Question CSC-32:

Question CSC-33:

Question CSC-34:

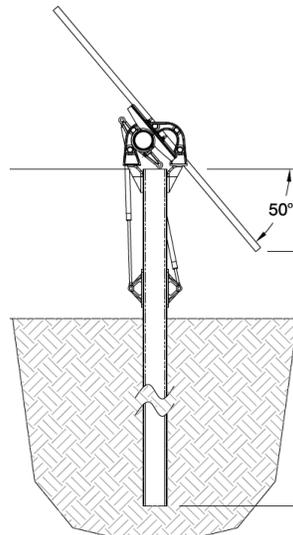
Question CSC-35:

What is the anticipated minimum and maximum height above grade of the solar panels?

Since this system is a single-axis tracker the height varies depending on the angle of the panel table to horizontal. The height of the system will be at its maximum 9ft-0in when its angle from horizontal reaches 50 degrees. The height of the system will be at its minimum 4ft-6in when the panel table lays flat at 0 degrees from horizontal. The bottom of edge of the solar panels will maintain a minimum of 1ft-0in from grade.
